Drive Warning Concept

Software Change Notification

Document SWSCN001_DriveWarningConcept_EP
Version 002₅₃
Source D:\SVNRoot\Doc\Software\SWSCN\
Destination T:\Doc\Software
Owner AB

Bild 2: Drive statemachine with FW>=1037

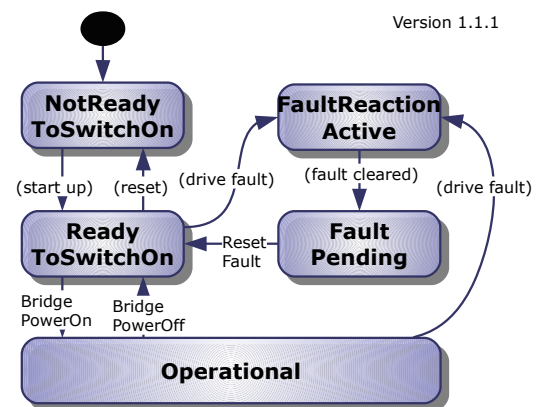
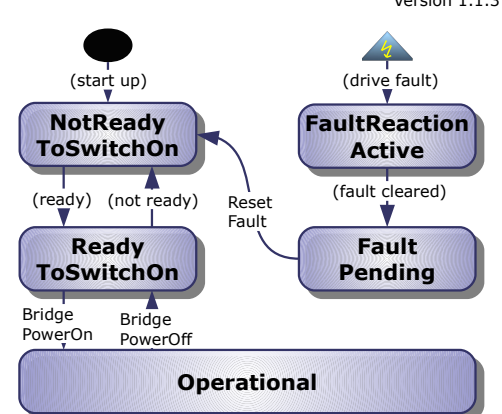
There is no global warning concept. The state 'ReadyToSwitchOn' just indicates that the drive has finished initialization. A potential problem like a missing bridge voltage or an open *SafeTorqueOff* input may be tested using dedicated registers but is not signaled as a state until the user tries to enable.

PowerBridgeVoltage limits are monitored in state 'Operational' only. Missing power or over-voltage in the state 'Operational' leads to switch off the drive with the error message 'BridgeVoltageOutOfRange' and the transition to the state 'FaultPending'. The error must be acknowledged using 'ResetFault', which results in a transition to the state 'ReadyToSwitchOn'. Only after an enable with faulty power, the error message 'BridgeVoltageOutOfRange' comes again.

PowerBridgeVoltage limits are monitored also in the state 'ReadyToSwitchOn'. The term "BridgeVoltageOutOfRange" is now either an **error** message (in state 'FaultReactionActive' or 'FaultPending') or a **warning** message (in state 'NotReadyToSwitchOn').

Missing power or over-voltage in the state 'ReadyToSwitchOn' leads to the **warning** 'BridgeVoltageOutOfRange' and the transition to the state 'NotReadyToSwitchOn'. Such a warning may not be reset. The drive can not be activated until the power is applied correctly. If the power is correctly applied, the warning disappears automatically and the drive changes to state 'ReadyToSwitchOn'. The drive can then be switched on.

Missing power or over-voltage in the state 'Operational' leads to switch off the drive with the **error** message 'BridgeVoltageOutOfRange' and the transition to

the state '*FaultPending*'. The error must be acknowledged using '*ResetFault*', resulting in a transition to the state '*NotReadyToSwitchOn*'. If power is correctly applied to the drive, it changes automatically to the state '*ReadyToSwitchOn*' in the next cycle and can then be switched on. If the power is still not ok, the drive remains in the state '*NotReadyToSwitchOn*' and in the next cycle, the **warning** '*BridgeVoltage-OutOfRange*' pops up.
